Evaluation of Physical Barriers- Hunter Park Station

Address: Hunter Park Metrolink Station, CA 92507

Evaluation Date: 08-03-2021

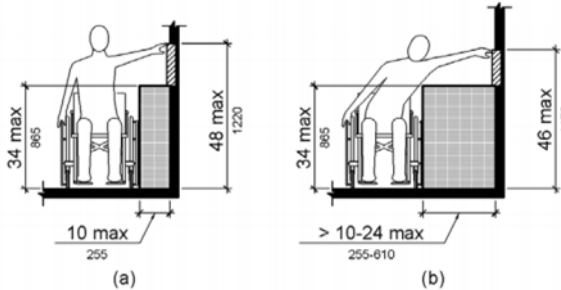
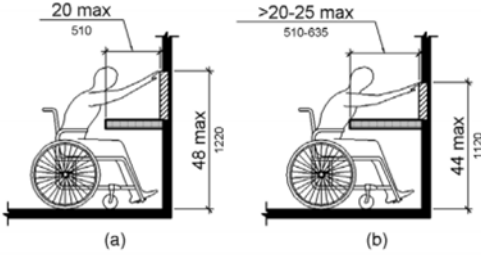
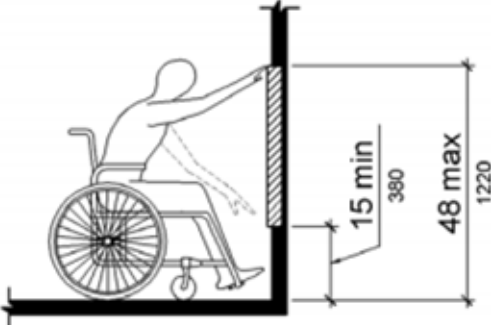
Issues/ Barriers Identified	Recommendations	Comments/ ADA Requirements
<p>2. Pedestrian Road crossings</p> <p>Pedestrian crossing at 2a, 2b has cracks, level changes more than 1/4" high, and gaps in excess of 1/2" wide and 1/4" deep.</p>   	<p>Examine all pedestrian crossings and repair all cracks.</p> <p>Every joint in concrete deeper than 1/4" and wider than 1/2" shall be filled.</p> <p>Every level change along the accessible route greater than 1/4" and less than 1/2" height needs to be beveled (1:2) slope or repaired.</p> <p>Every level change greater than 1/2" needs to have a ramped surface (1:12) slope.</p>	 <p>Figure 302.3 Elongated Openings in Floor or Ground Surfaces</p>  <p>Figure 303.3 Beveled Change in Level</p>  <p>Figure 303.2 Vertical Change in Level</p>
a) Pedestrian Push Button- Not Applicable	No action by RCTC
